Petition Number: 2023-046

General Review Information

Transportation Summary

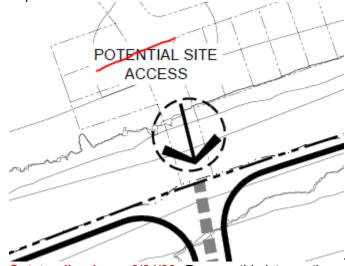
7. Outstanding Issue 8/24/23: Remove this intersection, and ensure all future horizontal curves meet the minimum CDOT standard of 150' radius.

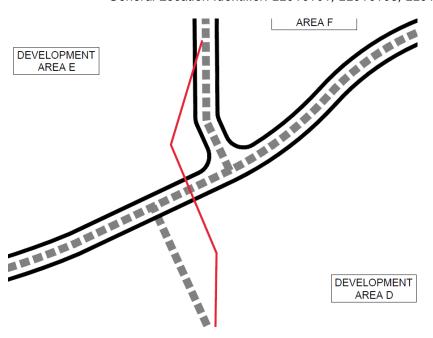
9. Outstanding Issue 8/24/23: The horizontal curves pictured below need to have a minimum 50' separation to meet minimum CDOT standard.
